Addendum #1

Date:	<u>March 31, 2025</u>	W&H Project:	<u>Audio Visual Systems</u>
Type:	<u>Addendum</u>	Project #:	<u>25-NPS-AVS-01</u>
Client:	<u>Northville Public Schools</u>	Project Mgr:	<u>Rob Richcreek</u>

Meads Mill MS Phasing/Logistics Plan

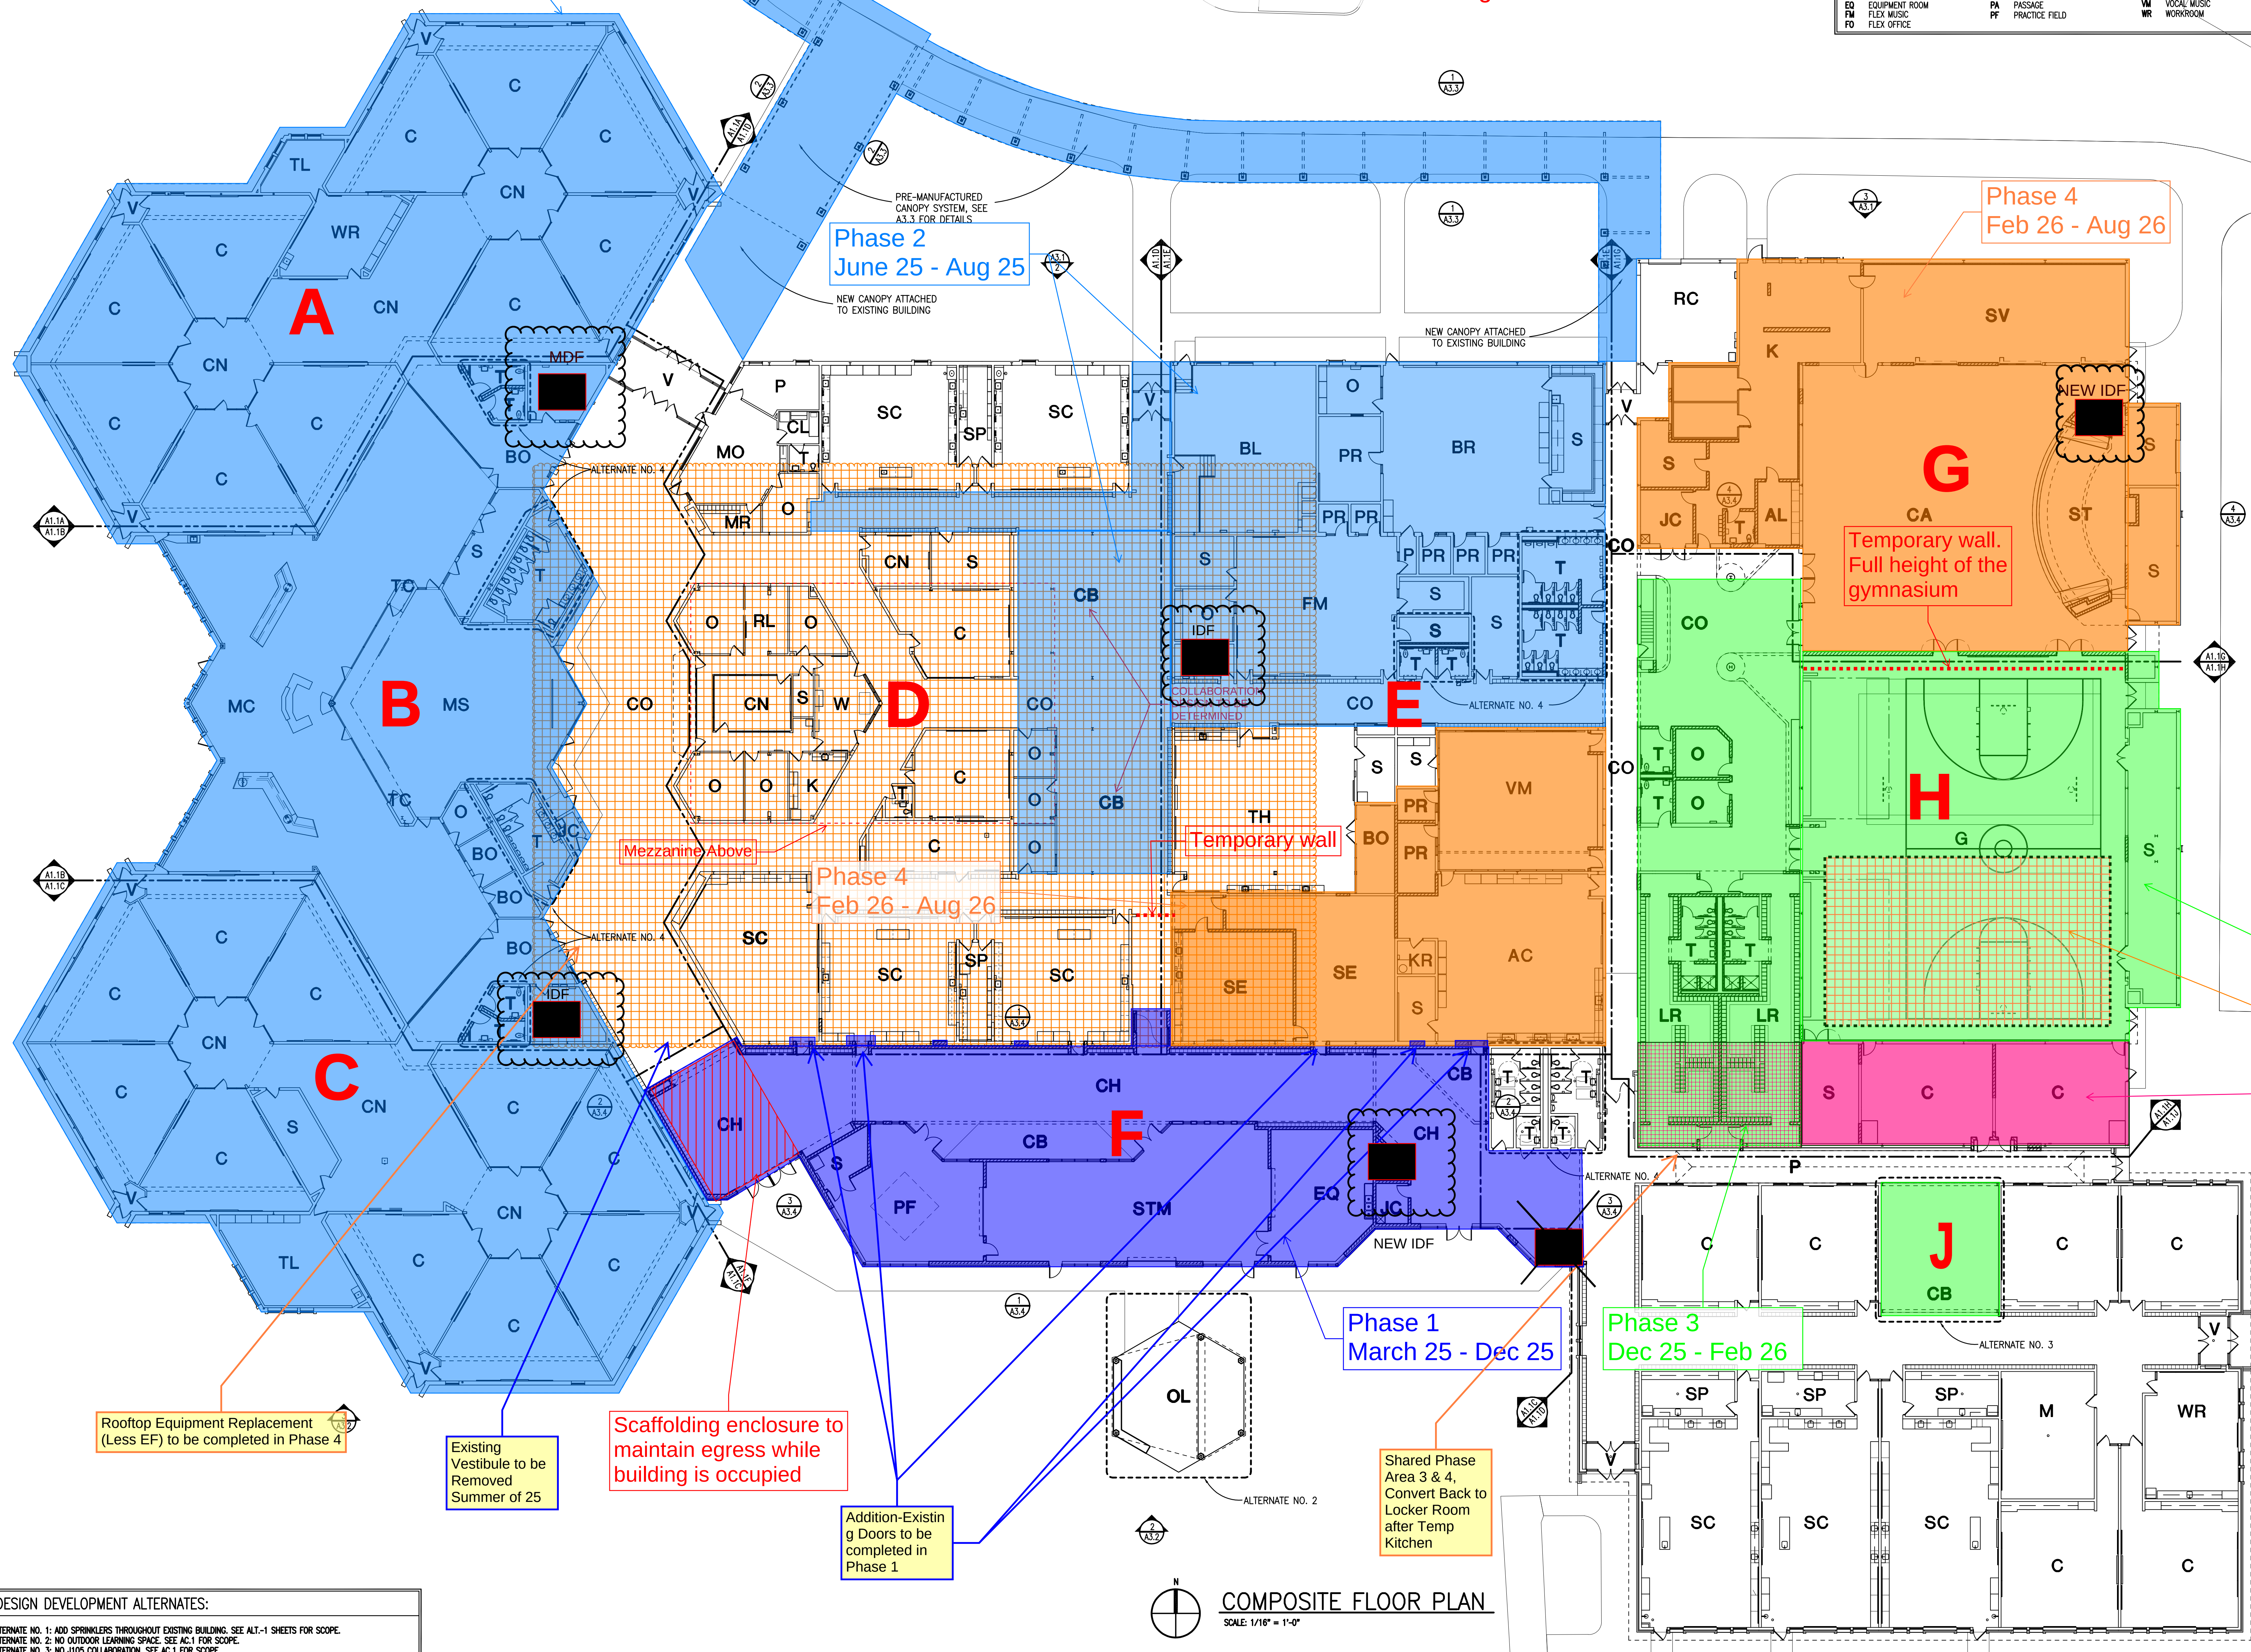
2. Project phasing drawings for Amerman Elementary School and Meads Mill Middle School are Attached in this Addendum.
